**LEBANON PLANNING BOARD
JANUARY 23, 2023 - 6:30 PM
COMMUNITY ROOM - KILTON LIBRARY - 80 MAIN ST,
WEST LEBANON
REMOTE VIA VIRTUAL PLATFORM
LEBANONNH.GOV/LIVE**

Staff Memorandum – PB2022-52-SPR

Application ID: PB2022-52-SPR

**Re: Milton Rents
Airpark Rd.
Subject parcel 131-3
IND-L Zone
Site Plan Review Request**

Sheet 16 (Landscape Plan 2)

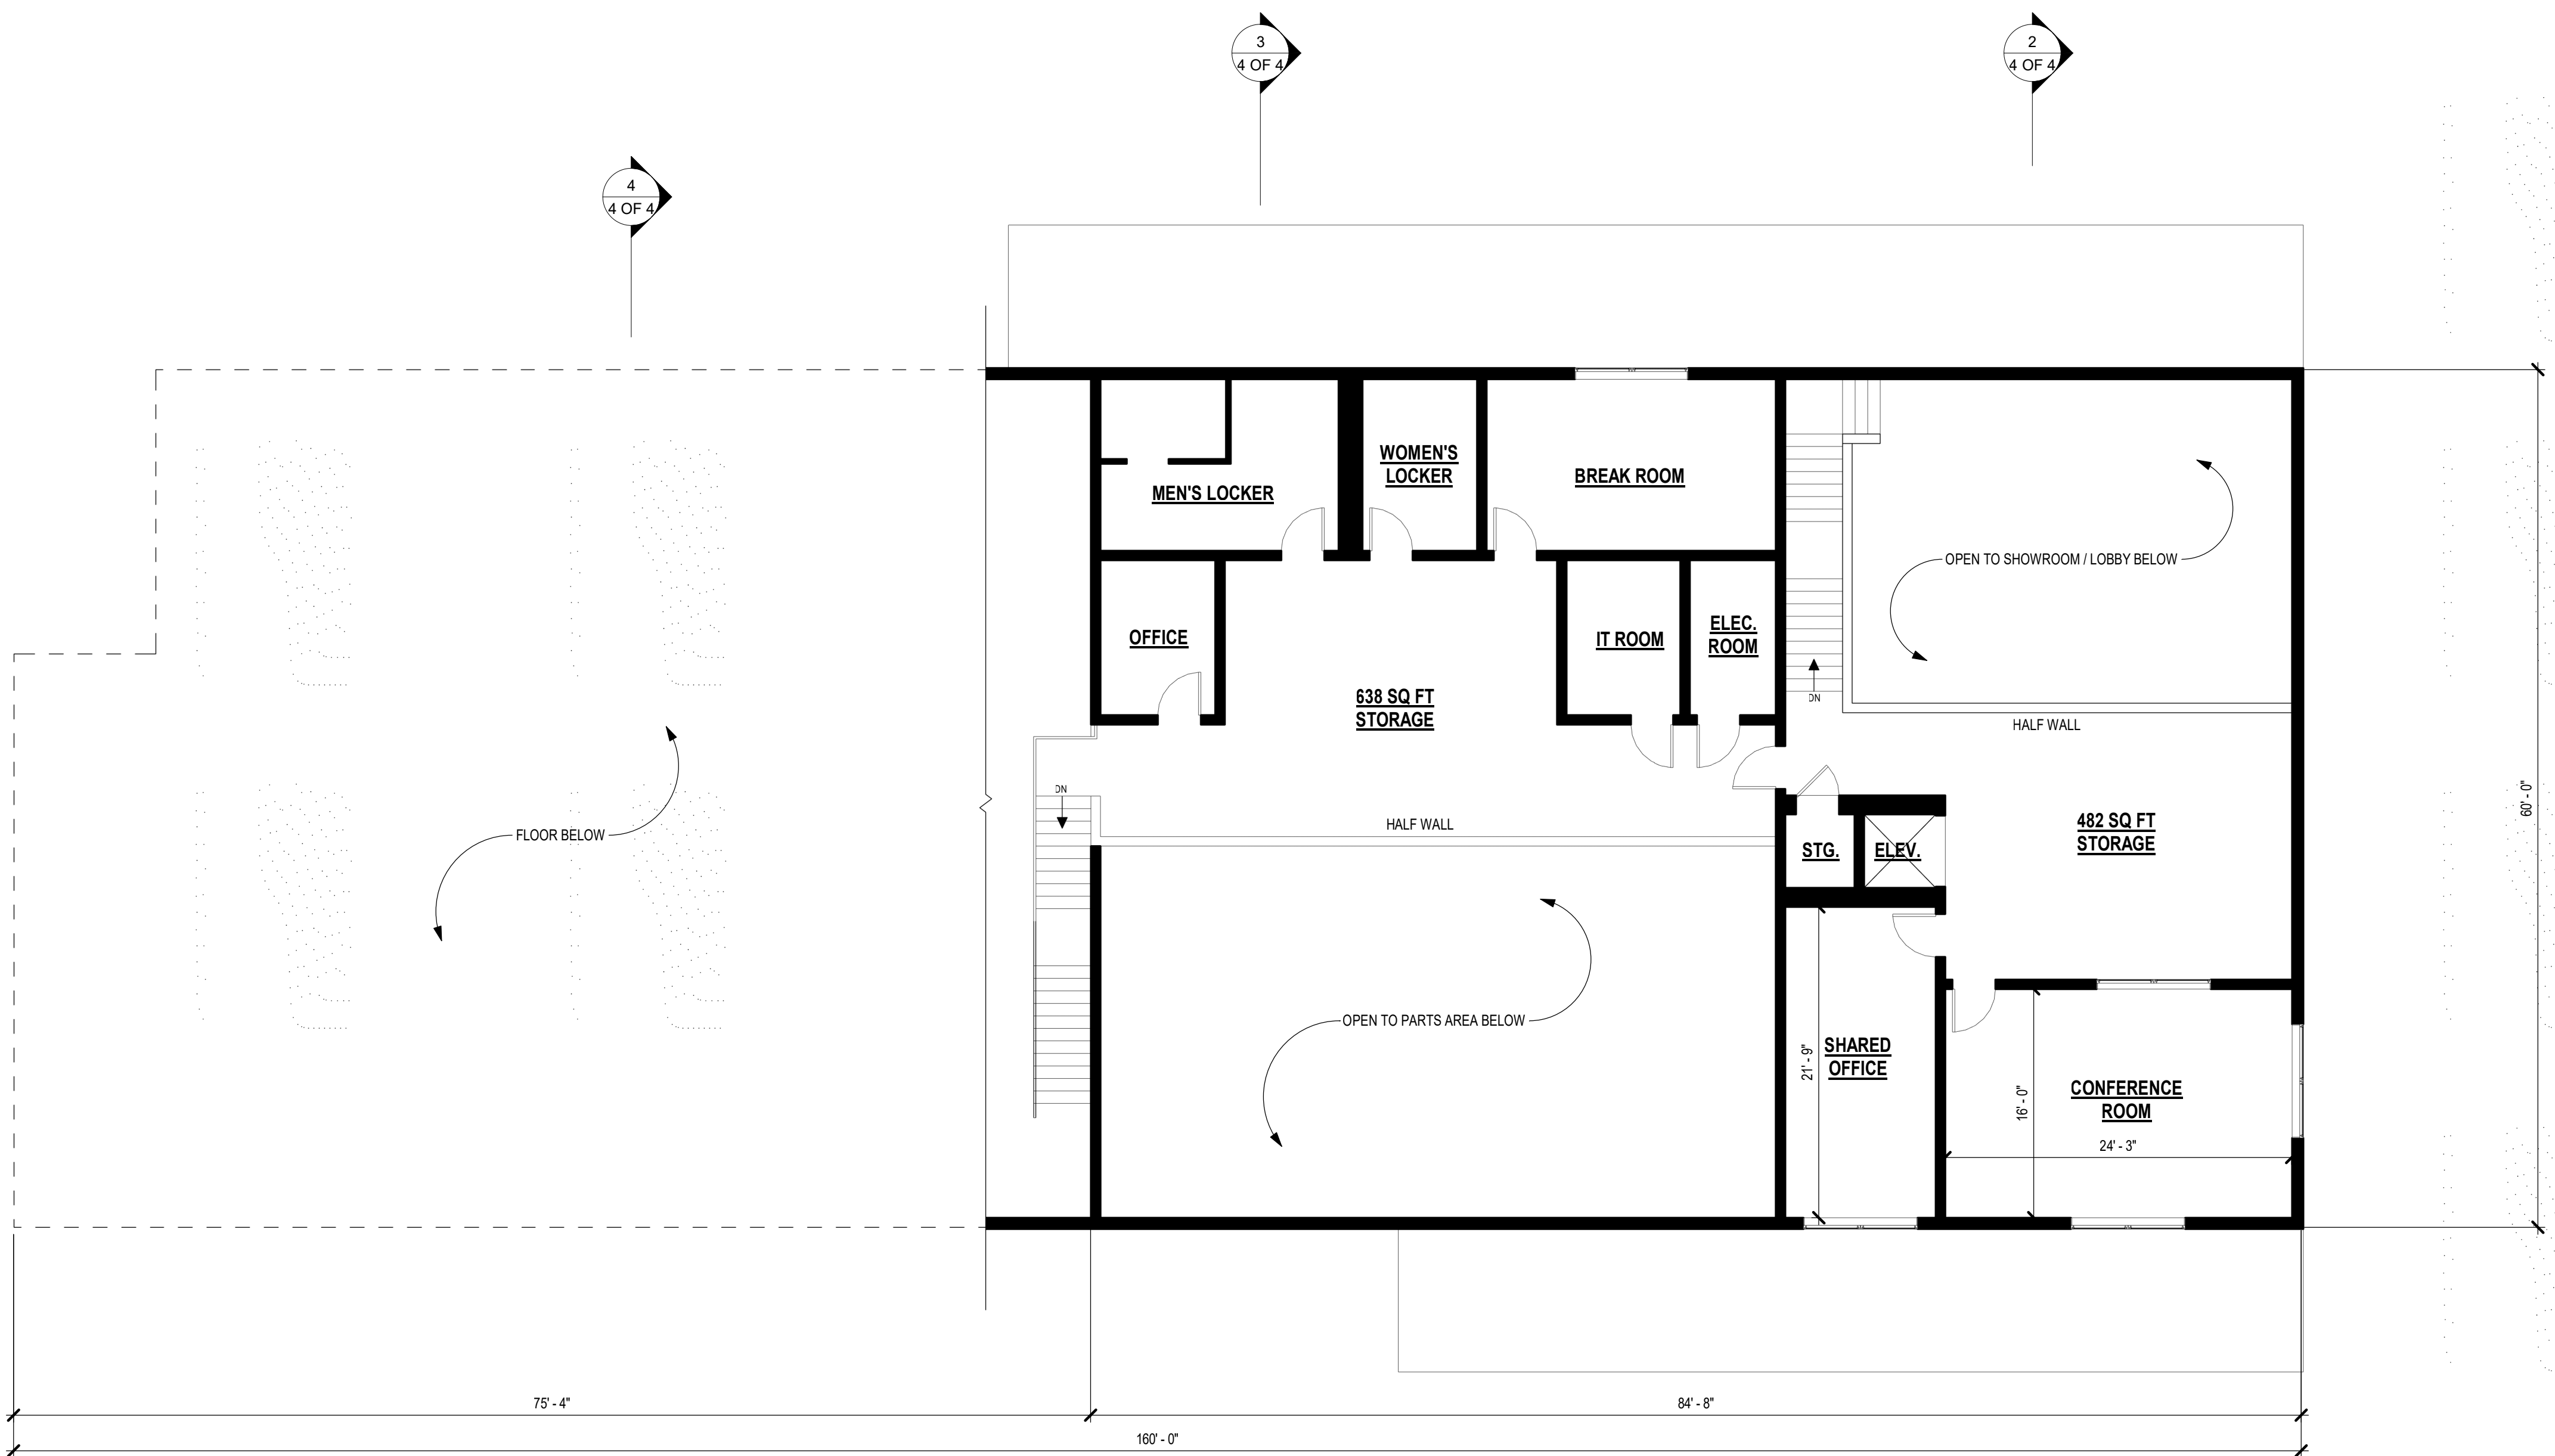
27. Add landscape bed at least 8 ft in width as required by Section 6.2.E.2, in the area shown below:

Landscape island has been added to the plan
